Model: Model K-P1		Date: 18-Jan-01	No.: RG058001
Subject: Printer Controller Firmware History		Prepared by: K. Misugi	
From: Technical Services Dept., GTS Division			
Classification:	<input type="checkbox"/> Troubleshooting	<input type="checkbox"/> Part information	<input checked="" type="checkbox"/> Action required
	<input type="checkbox"/> Mechanical	<input type="checkbox"/> Electrical	<input type="checkbox"/> Service manual revision
	<input type="checkbox"/> Paper path	<input type="checkbox"/> Transmit/receive	<input type="checkbox"/> Retrofit information
	<input type="checkbox"/> Other (        )

Printer controller firmware history for the Kir-P1 (G058/G056 model).

Model: Model K-P1		Date: 03-Apr-01	No.: RG058002
Subject: Printer Engine Firmware History		Prepared by: K. Misugi	
From: Technical Services Dept., GTS Division			
Classification:	<input type="checkbox"/> Troubleshooting	<input type="checkbox"/> Part information	<input type="checkbox"/> Action required
	<input type="checkbox"/> Mechanical	<input type="checkbox"/> Electrical	<input type="checkbox"/> Service manual revision
	<input type="checkbox"/> Paper path	<input type="checkbox"/> Transmit/receive	<input type="che

### Dirty background on the right side:

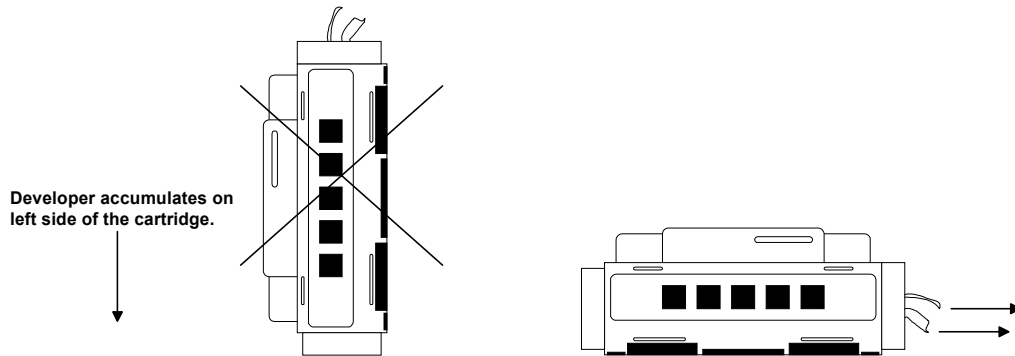
The developer will shift to the left side if the cartridge is tilted as shown below when the sealing tapes are being removed. This causes toner to be over-supplied on the right side of the cartridge, which in turn causes the dirty background on the right side of the printout.

When removing the tape, place the machine on a level surface.

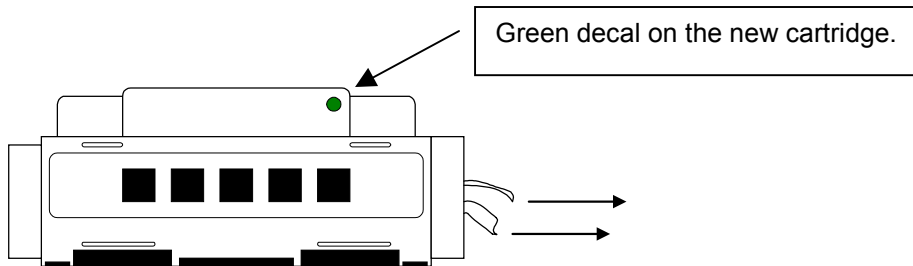
The cartridge has been modified from June production so that dirty background will not occur at installation even when the cartridge is tilted.

A green decal is added so the new cartridge can be distinguished from the old type. The same decal is also placed on the supply cartridge, next to the bar-code label on the box.
